Access Compliance Report

Public Rights-of-Way

Intersection ID: 14713	Main Street: CHICAGO_AV	Cross Street: MILLER_ST	Location:	N
ADA ID: DBE6068747CF	Ramp Type: PerpDiag	Initial Pass/Fail: Fail	Overall Compliance: No	Severity Score: 33.75
Codes/Mitigation Info/Possible Solution		Field Measurements/Component Compliance

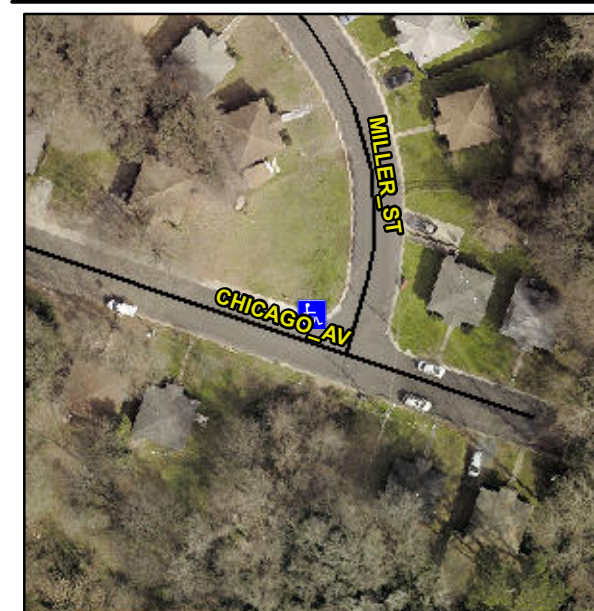
Not Found, R304.5.1, R304.5.3

Compliance	Description	Data	Compliance	Description	Data
N/A	Ramp Length (in)	64.0	Yes	Ramp Slope (%)	5.9
No	Ramp Width (in)	40.0	No	Ramp XSlope (%)	14.9
N/A	Flare Type LT	N/A	N/A	Flare Type RT	N/A
N/A	Flare Slope LT (%)	N/A	N/A	Flare Slope RT (%)	N/A
N/A	Flare Traversable LT?	N/A	N/A	Flare Traversable RT?	N/A
N/A	Landing Length (in)	N/A	N/A	DWS Provided?	N/A
N/A	Landing Width (in)	N/A	N/A	DWS Contrast?	N/A
N/A	Landing Slope (%)	N/A	N/A	DWS Length (in)	N/A
N/A	Landing X Slope (%)	N/A	N/A	DWS Full Width?	N/A
N/A	Landing Curb? (Y/N)	N/A	N/A	DWS Offset (in)	N/A
N/A	Shared Landing?	N/A			
N/A	Gutter Ponding?	N/A	N/A	Gutter Slope (%)	N/A
N/A	Gutter Lip Ht (in)	N/A	N/A	Gutter X Slope (%)	N/A
N/A	Painted X Walk1?	No	N/A	Painted X Walk2?	No
	X Walk 1 Direction	To SW		X Walk 2 Direction	To SE
N/A	X Walk 1 Width (in)	N/A	N/A	X Walk 2 Width (in)	N/A
	X Walk 1 Slope (%)	6.9		X Walk 2 Slope (%)	6.7
	X Walk 1 X Slope (%)	9.5		X Walk 2 X Slope (%)	17.2

Remove & Replace Curb Ramp With Two New Directional Ramps or Equivalent.
